IloT Product End-of-Life Notice

End of Life, Last Time Buy and Replacement Announcement

For immediately release, Advantech is announcing the End of Life (EOL) of [AIMC-2000J-HDA1E](#). The relative replacing models are as below list. Customers who had purchased this Part Number either to purchase any additional rules or migrate to the new replacement models if possible before the EOL's shipment date.

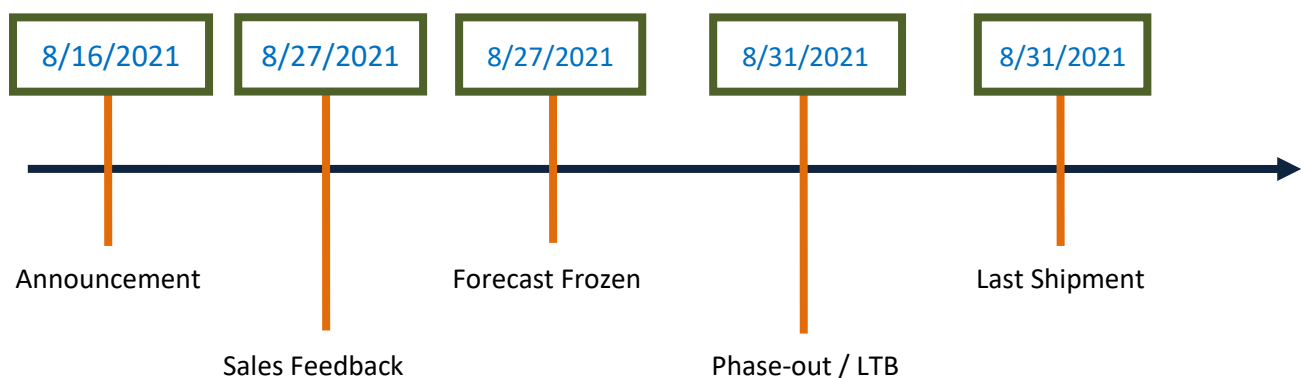
- Realtek LAN IC 1410021647 (RTL8111E-VL-CG) phased out. Change to use 1410024683-01 (RTL8119I-CG).
Note: No impact on software compatibility.
- Due to no available supply of 1410021647 after September, phase out on 8/31/2021 and replaced by new part number from 9/1/2021 immediately.

End of Life Product	Suggest Replacement Product	Sample Available Date
AIMC-2000J-HDA1E	AIMC-2000J-00A2	Now
